TB10045

Topic: New solenoid Part No 1502148		<u>TB No.:</u> 10045	<u>Date:</u> July 2017
Affected Machines:	PB5/ PB10	Priority: Low	Created By: Gareth Fitzpatrick
From Serial No.:		Created For: Technicians	Part Update
From Date:	Jan 2017	Pages:_1/2

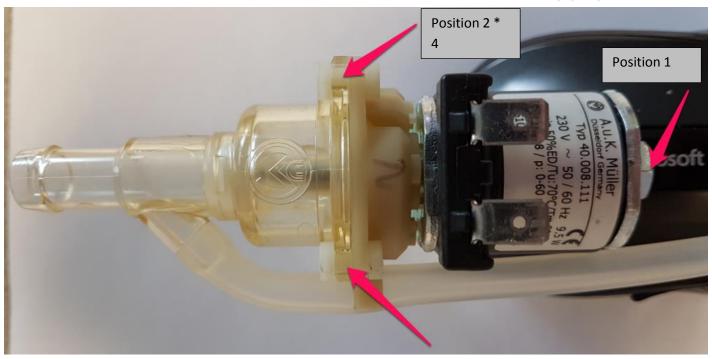
Dispense solenoid 1502156 has been replaced with <u>1502148</u> as part of a part improvement. The only noticeable difference is the physical size of the solenoid coil which is larger.

- The dispense solenoid you receive may have a different orientation to the one in the machine.
- There is two options to adjust the orientation

Loosen the 10 mm screw on the top of the coil and rotate as necessary. Position 1

- Remove the four white securing pins and change the orientation of the inlet/ Outlet as desired. Position 2
- Secure in position with the 4 white securing pins.
